Product Change Notice (PCN)

Subject: Part Marking Change for the Listed Intersil HSx-1840xxH / DLA SMD 5962-95630 Products

Publication Date: 8/18/2015

Appendix B:

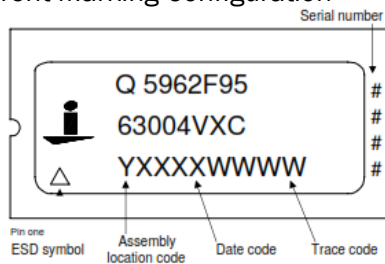
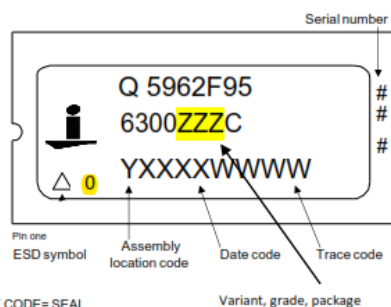
Modify HSx-1840xxH Brand to add ESD class code as defined in MIL-STD-883 TM3015 Table III.

Provide unit level identifier showing the ESD rating/sensitivity of this particular product. There is NO change to the ESD rating of the product.

New Marking Configuration (SBDIP shown as example, all versions to have a 0 after ESD symbol – see MIL-PRF-38535 para:)
